Request for Offer Amendment

1. SOLICITATION TYPE (Check one) SEALED OFFER X NEGOTIATED		2. DATE ISSUED August 25, 2003	RFO NUMBER/AMENDMENT NUMBER RFO2-38206 TAM Amendment #1	3. PAGE 1 of 1

6. CLOSING DATE/TIME: 2:00 PM, September 9, 2003; Past Performance Information Due: August 27, 2003				
7. DESCRIPTION OF REQUIREMENT RFO2-38206, HVAC REPLACEMENT, BUILDING N233 AT NASA AMES RESEARCH CENTER, MOFFETT FIELD, CALIFORNIA

The following clarifications and changes are to be incorporated into the referenced specifications and drawings.

Section 6
Edge of opening & supporting members 53

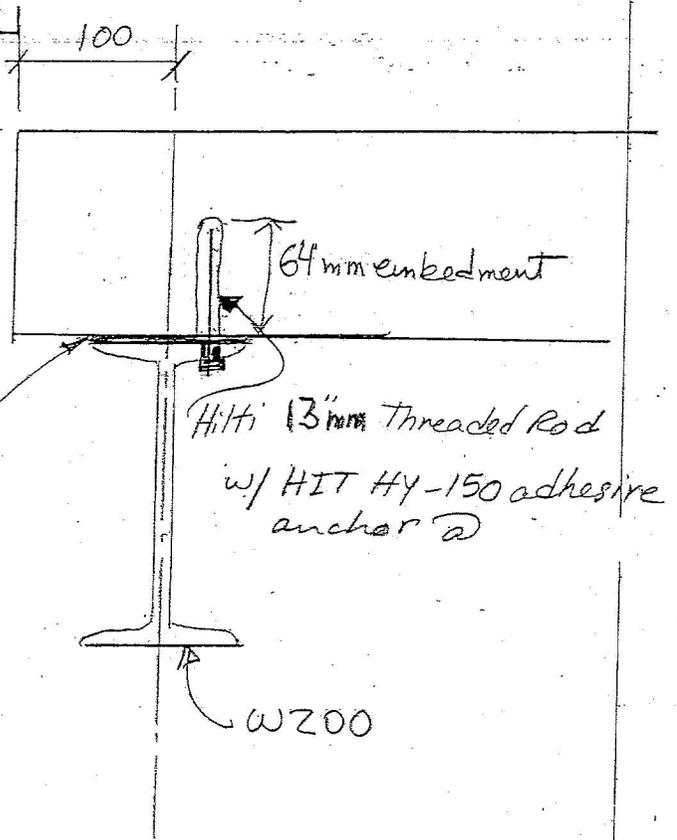
Dwg. A233-0301-S03: Delete one W200 beam parallel to and next to column line 21, shown on Detail A. Replace Detail 6 with new Detail 6 shown on the attached sheet dated August 18, 2003. At Detail 1 & 2, delete the 25mm puddle welds at the roof decking. At note #1: steel beams are for second floor slab and for roof deck support. At note #2: Epoxy is to cure to full strength based on manufacturer's recommendation. Concrete pad shown in Detail B is part of Option Item #3.

Saw cut slab after completion of (N) steel beam, core drill all corners to avoid overcut.

Adhesive Anchors Epoxy shall be cured to 140mm full strength base on manufacturers recommendation prior of installation of Beam

Fully Grouted to ensure full contact w/ Conc. slab
